Hydro One Networks Inc. Transmission
Application for electricity transmission revenue requirement and related changes to the Uniform
Transmission Rates beginning January 1, 2017 and January 1, 2018

AMPCO Submissions

Figure 37: Forced Outage Duration due to Steel Structure Failures

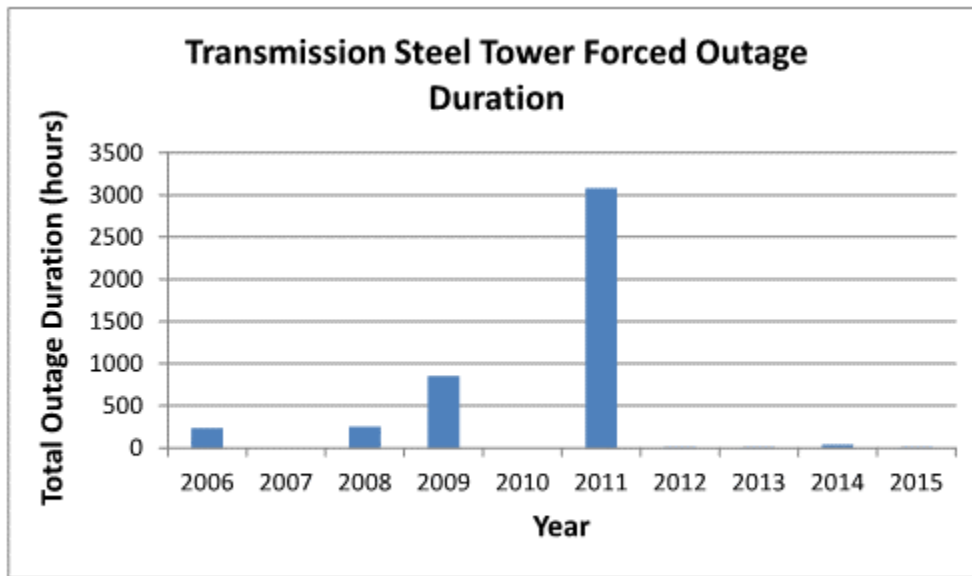
AMPCO wishes to point out that corrosion and metal loss is a slow process. There is nothing in the evidence to suggest large quantities of towers are exceeding corrosion and metal loss thresholds in the near term. HONI's evidence is that the steel structure condition assessment has been initiated based on demographics, geographic zones and the result of a study conducted by industry experts over the past several years but the initial assessment results need to be verified by inspections, patrols and detail corrosion assessment. AMPCO submits that such a significant ramp up in spending is not justified at this time given that assessment results still need to be verified.

Figure 1: Transmission Lines Sustaining CAPEX per Asset

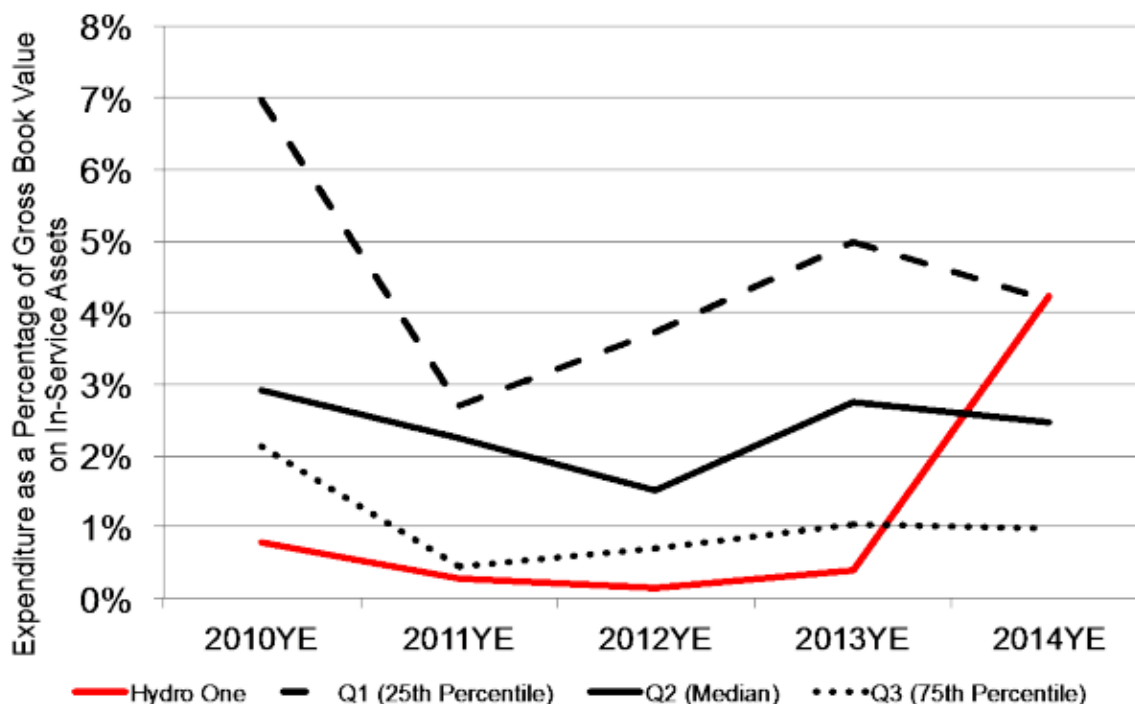
- The key cost driver of HONI's transmission investment plan is sustaining capital. In response to Undertaking J3.3, HONI recast Figures 10 and 15 of the Navigant Report, to show sustaining lines CAPEX spending only instead of total transmission lines CAPEX per asset (Figure 10) and total substations CAPEX per asset (Figure 15) for the years 2010 to 2014.
- J3.3 shows that for the years 2010 to 2012 HONI's sustaining spending on transmission lines is below its peers, however, by 2014 this trend has reversed and HONI's sustaining spending is at the highest level, noting that the spending trend for peer transmission utilities shows a decline between 2013 and 2014.

Figure 2: Substations Sustaining CAPEX per Asset

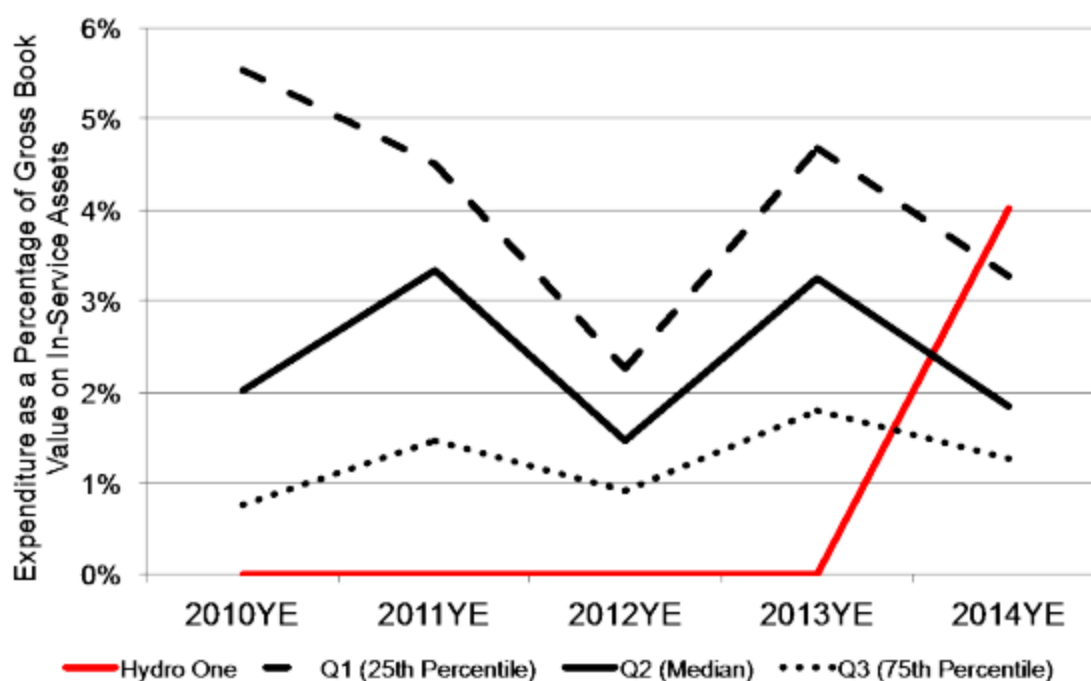
highest in the peer group.¹²⁸ It is unclear to AMPCO why 0% is shown for the years 2010 to 2013.

Given that the key driver for HONI's proposed increase in capital spending is related to sustaining capital, AMPCO submits the Board should place more weight on the sustaining capital investment trends than total CAPEX. As such, AMPCO submits that the sustaining CAPEX trends do not show that HONI's spending on its sustaining capital (stations and lines) is less than comparators beginning in 2014.

Figure 11. Transmission Lines CAPEX (Activity-Based) per Asset

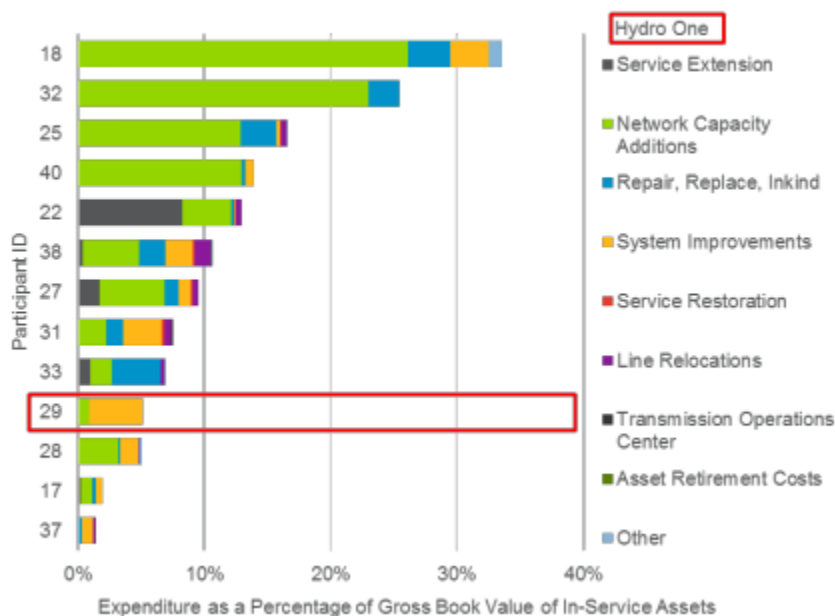
Sustaining capital is approximately 80% of HONI's total capital investment for transmission lines.¹³⁰ Figure 11 from the benchmarking study shows that relative to the peer group HONI is spending more of its capital on sustaining than any of its peers who are largely spending on network capacity additions. Capacity additions is generally a response to either increases in system demand or additions of new transmission customers that do not have ready access to existing facilities. HONI's demand has been stable for years and still below 2006 levels so it is logical to expect that HONI would have a lower cost structure than its peers.

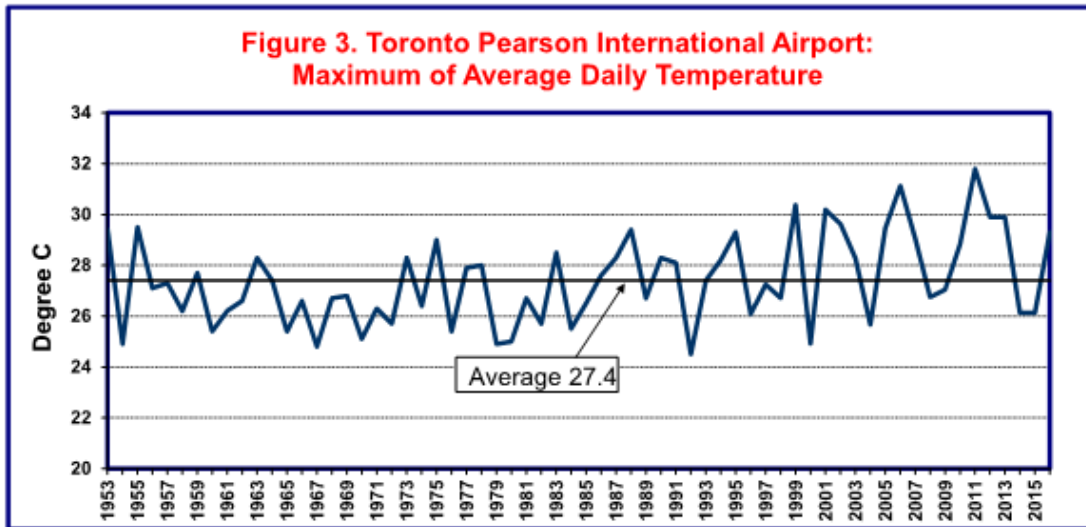
AMPCO does not agree the trend in maximum average daily temperatures has been broken since 2014. In response to AMPCO undertaking, JC1.14, HONI provided additional average daily temperature data to September 30, 2016 on Figure 3 (Maximum of Average Daily Temperature) which shows that the trend line is above the average line in 2016 reflecting record high temperatures in 2016. AMPCO notes average daily temperatures by nature fluctuate up and down but for the past 20 years temperatures
